**ADDENDUM NO. 1**

**AUTOMATED PEOPLE MOVER OPERATING SYSTEM  
SUPPLIER ELIGIBILITY DETERMINATION**

**LANDSIDE ACCESS MODERNIZATION PROGRAM**

**LOS ANGELES INTERNATIONAL AIRPORT**

PROFILES ARE BASED ON NORTH TRACK; SOUTH TRACK TO BE SIMILAR

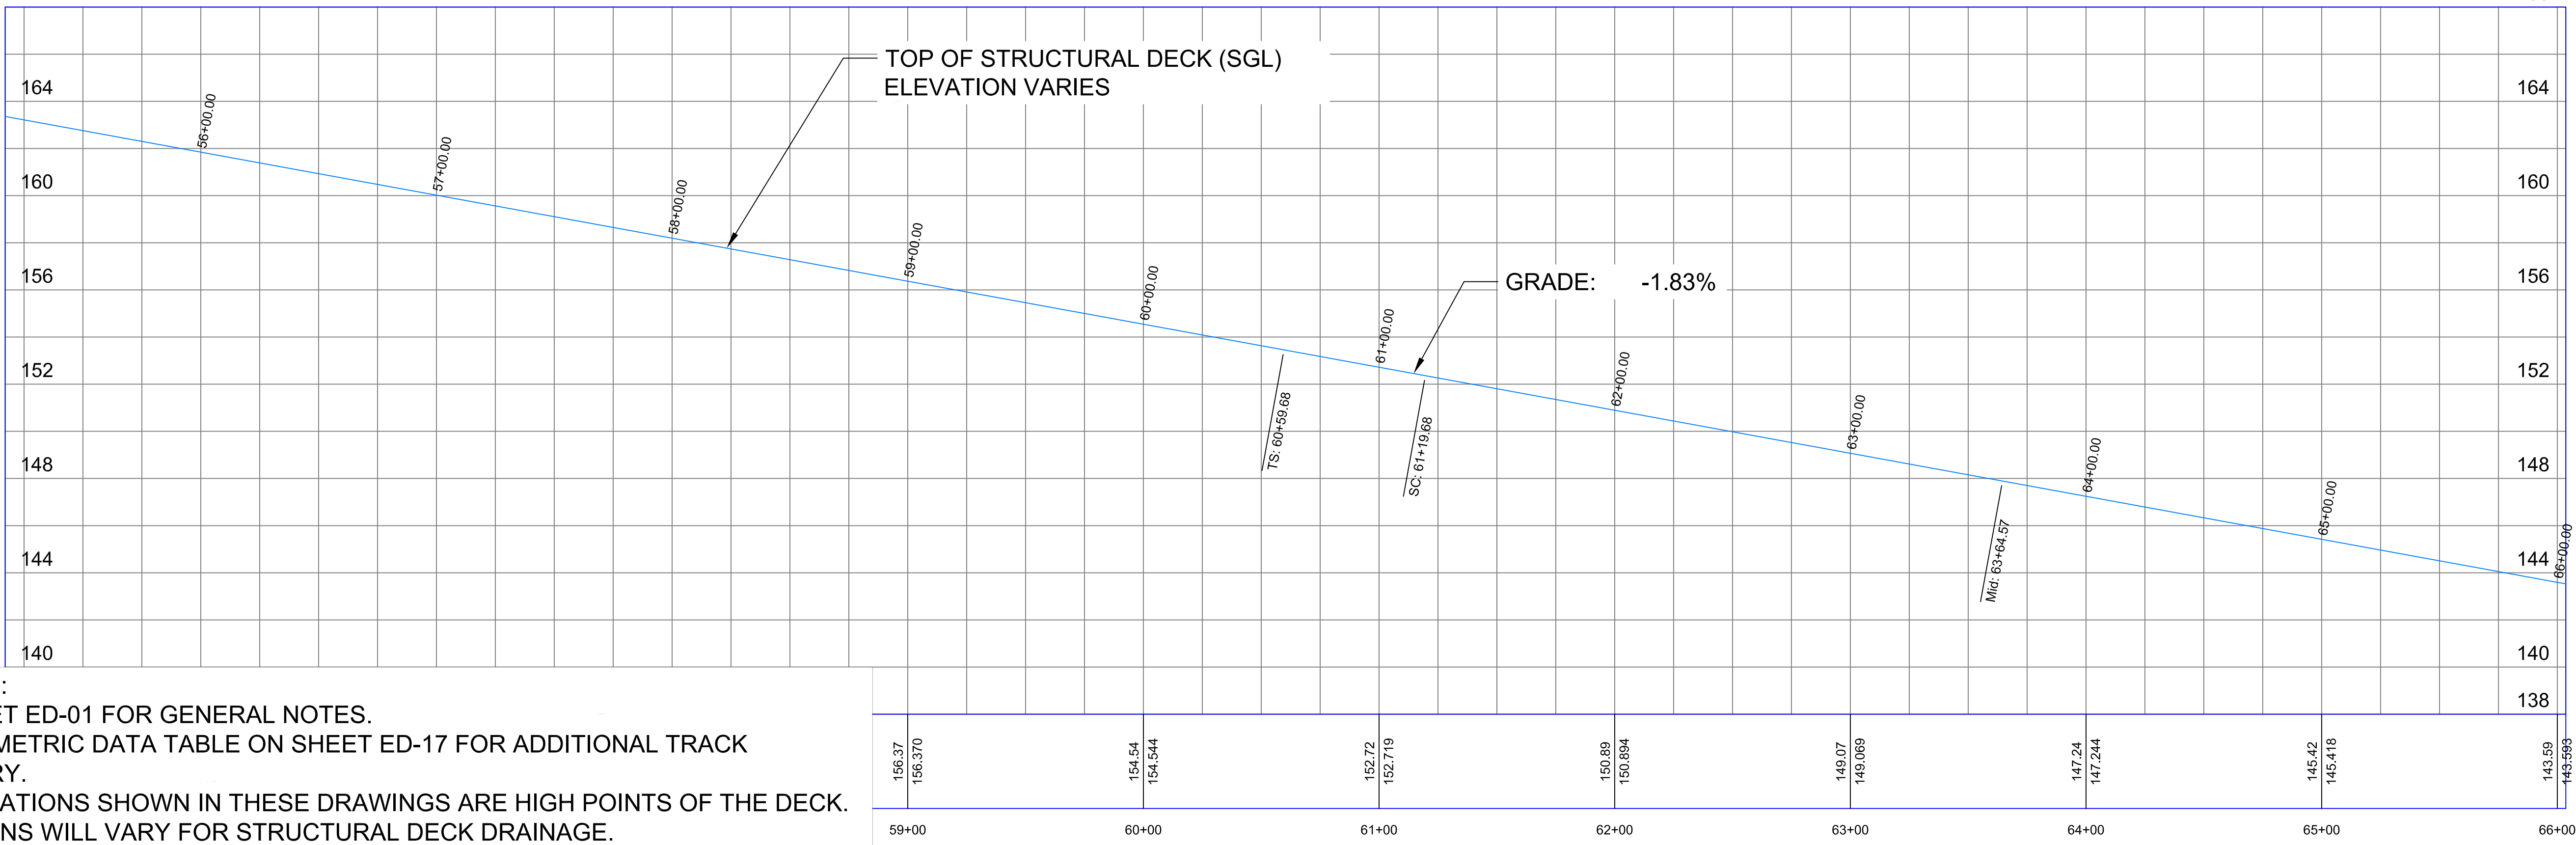
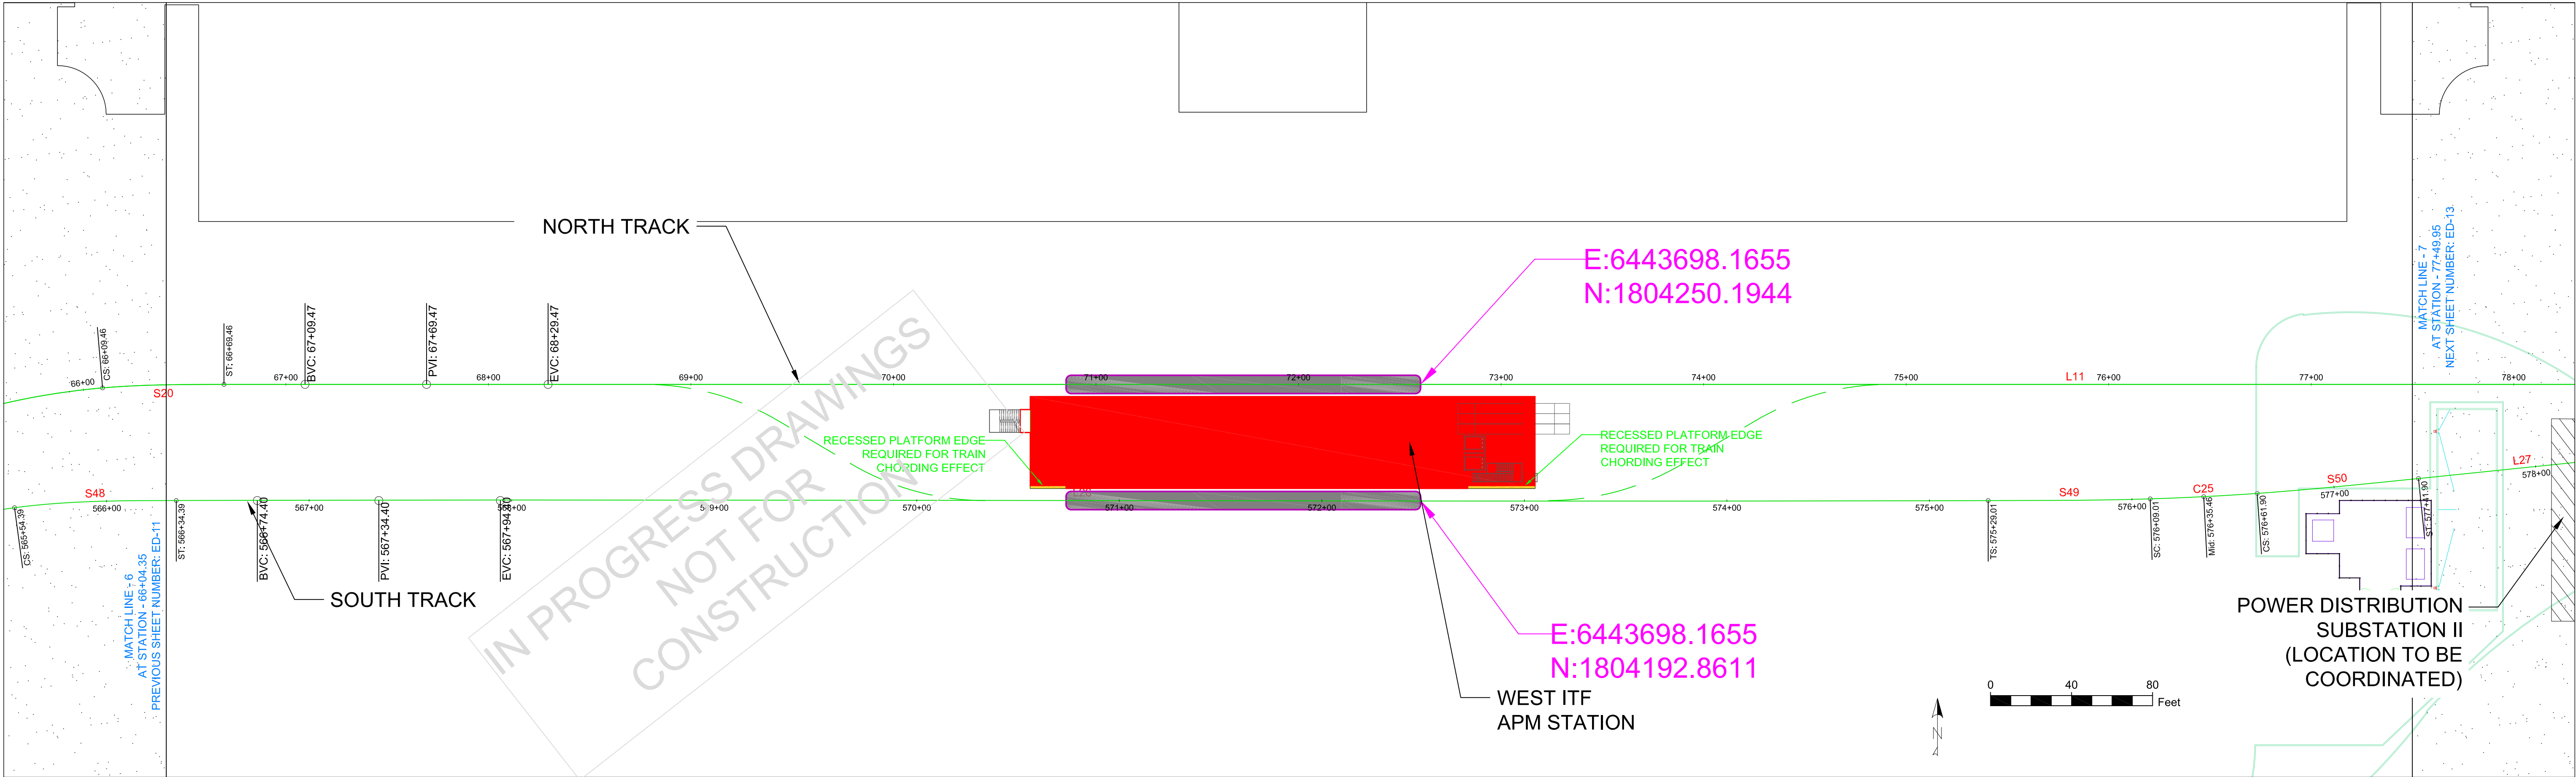
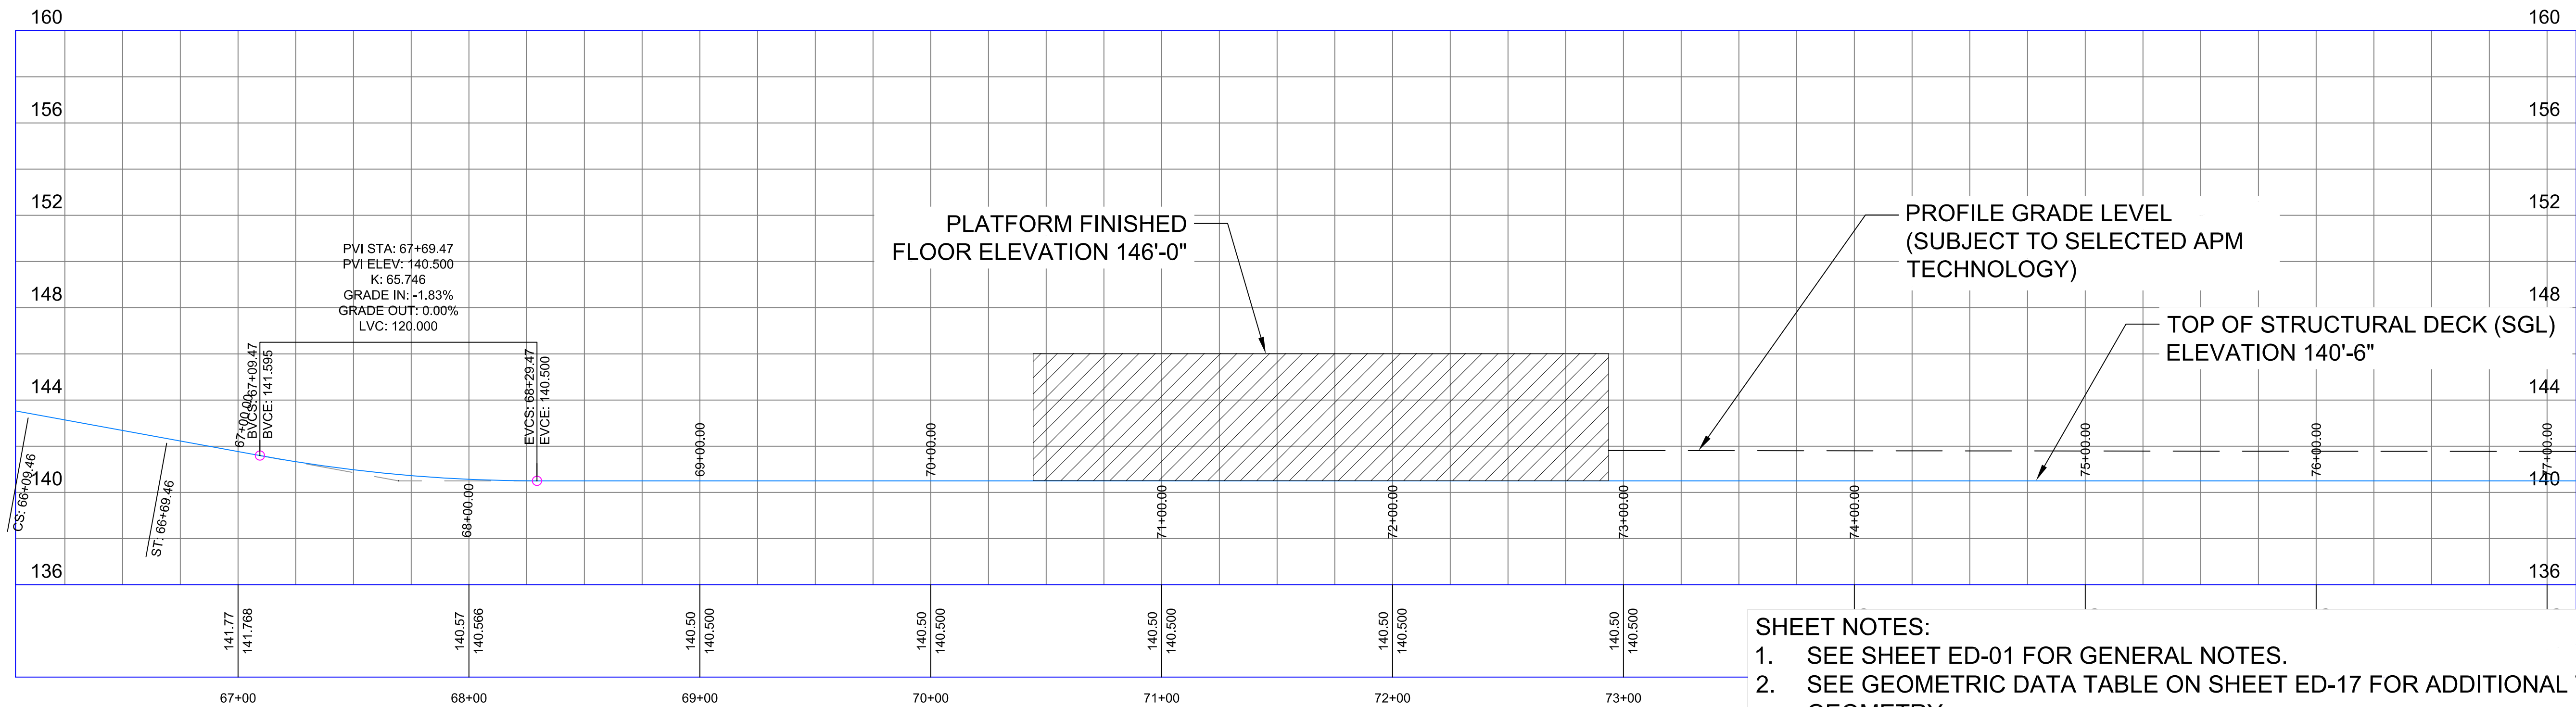
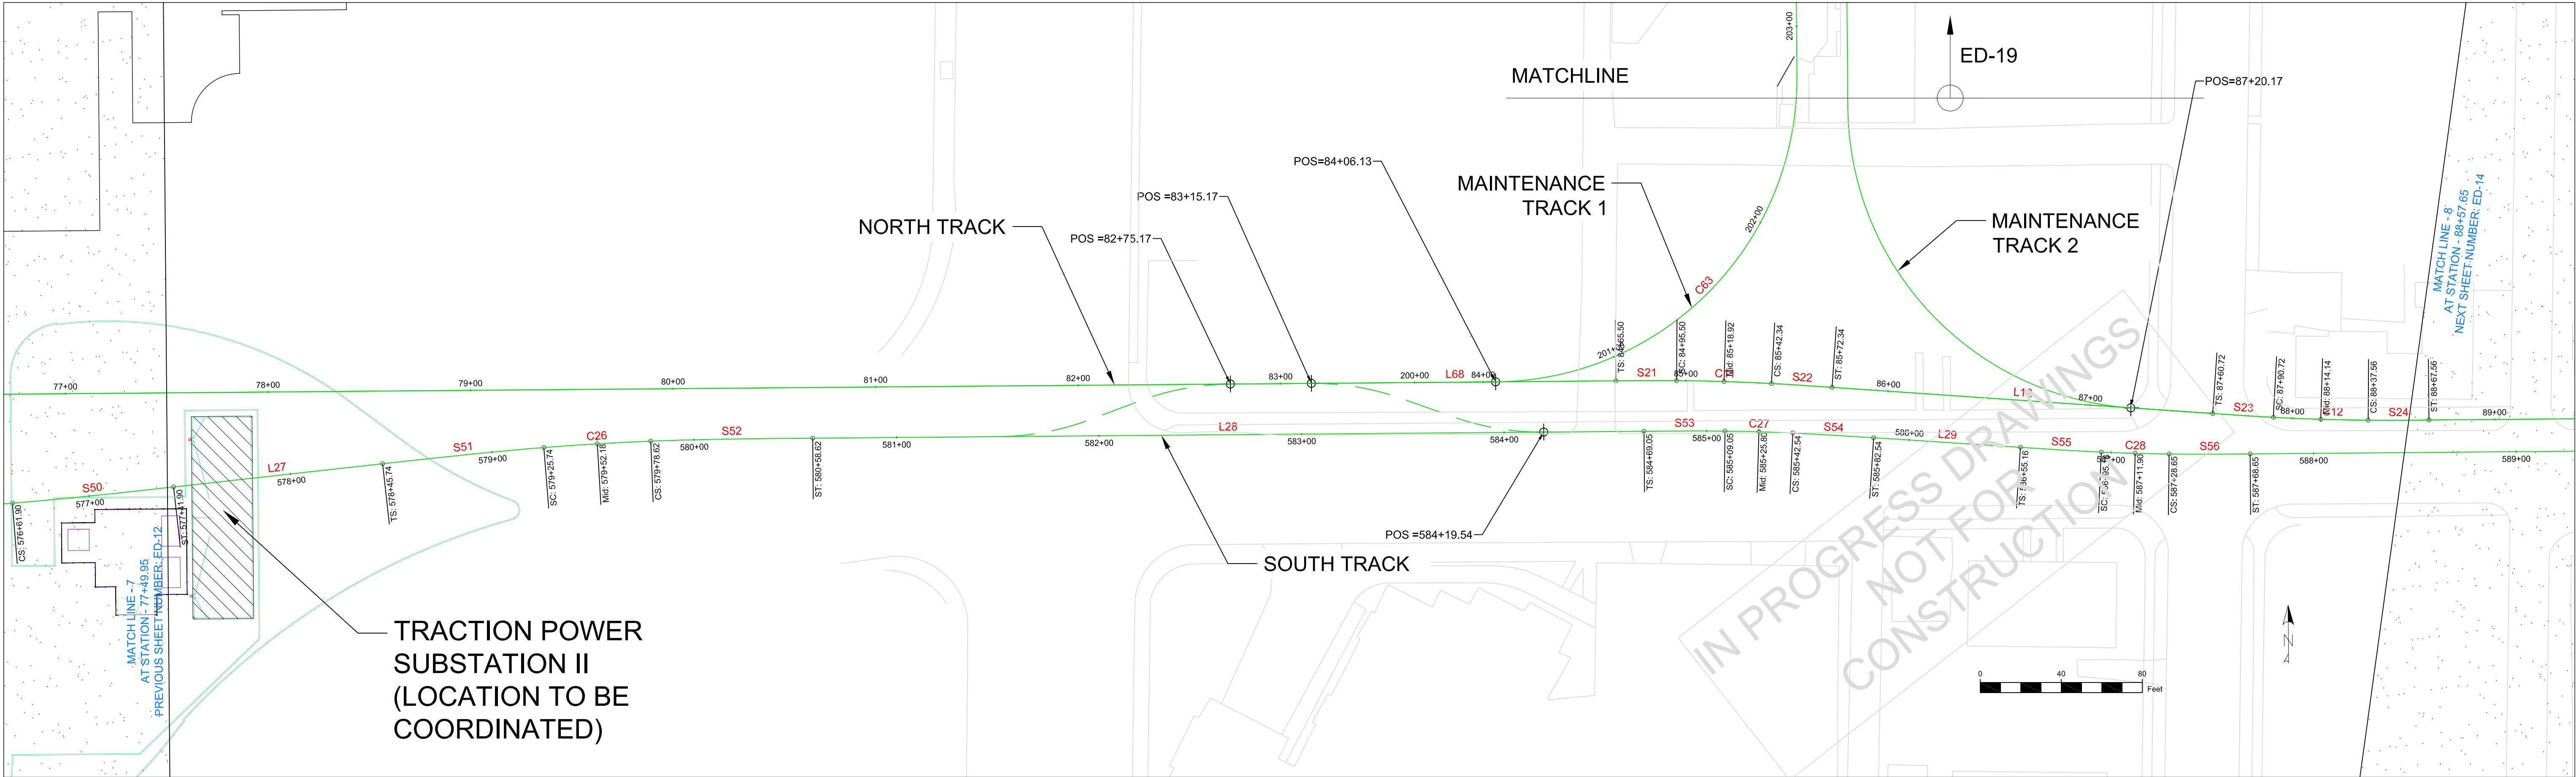
**RFC 5 :** Attachment 4 – Sheets ED-17 and ED-18. We reviewed and re-created the alignment stationing and find that there is a discrepancy between the alignment stationing (created from the curve data) and the alignment stationing shown on sheets ED-09 through ED-16. A similar discrepancy is observed on Sheets ED-03 through ED-05. Please clarify.

- a. Replace sheets ED-04, ED-05, ED-09 through ED-16, and ED-19 with attached sheets ED-04, ED-05, ED-09 through ED-16, and ED-19, Addendum 1 – May 5, 2016. Revised sheets incorporate a correction to the stationing on the sheets.

**RESPONSE 5:** Refer to the revised Sheets ED-04, ED-05, ED-09 through ED-16, and ED-19 for Attachment 4 in Addendum 1 – May 5, 2016.
